**SUNDRY NOTICES AND REPORTS ON WELLS**  
*Do not use this form for proposals to drill or to re-enter an abandoned well. Use form 3160-3 (APD) for such proposals.*

1. Type of Well <input type="checkbox"/> Oil Well <input checked="" type="checkbox"/> Gas Well <input type="checkbox"/> Other		8. Well Name and No. COTTON DRAW UNIT 117H
2. Name of Operator DEVON ENERGY PRODUCTION CO., L.P. Contact: TRINA C COUCH E-Mail: TRINA.COUCH@DVN.COM		9. API Well No. 30-015-38434
3a. Address DEVON ENERGY PRODUCTION CO., LP 333 WEST SHILP OKLAHOMA CITY, OK 73102-5015	3b. Phone No. (include area code) 918-226-0720 OKLAHOMA CITY, OK 73102-5015	10. Field and Pool, or Exploratory BONE SPRING
4. Location of Well (Footage, Sec., T., R., M., or Survey Description) Sec 34 T24S R31E 160FSL 1980FEL		11. County or Parish, and State EDDY COUNTY COUNTY, NM

Devon Energy Production Company, L.P. respectfully requests approval to change the SHL to the following:

WELL LOCATION AND ACREAGE DEDICATION PLAT

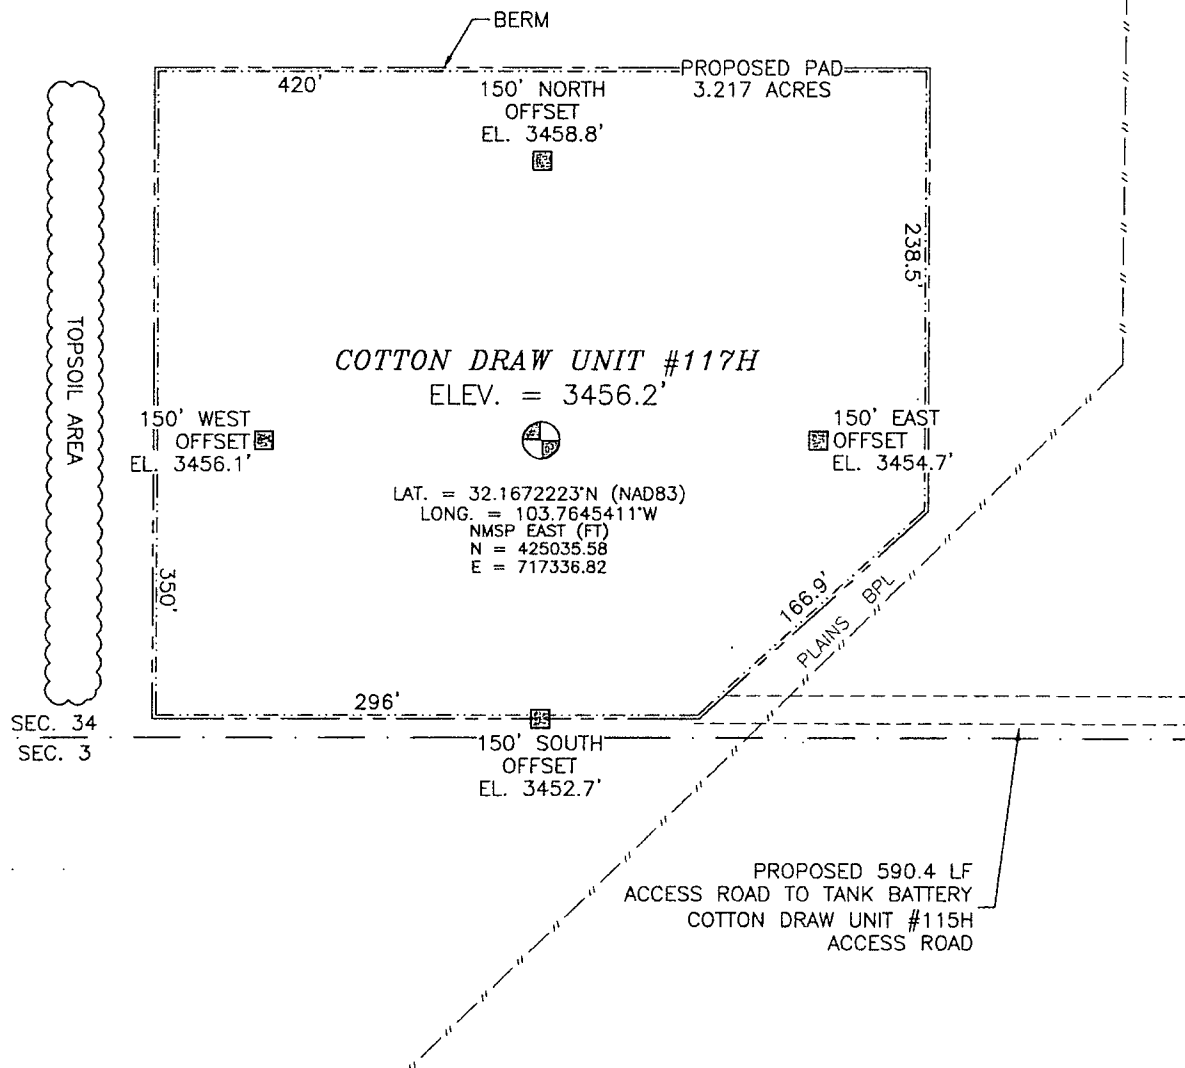
Current Location: SHL: 160' FSL & 1980' FEL  
BHL: 660' FNL & 1980' FEL (Remains the same)

160FSL & 2280 FEL

Proposed Location: SHL: 160' FSL & 2280' FEL  
BHL: 660' FNL & 1980' FEL (Remains the same).
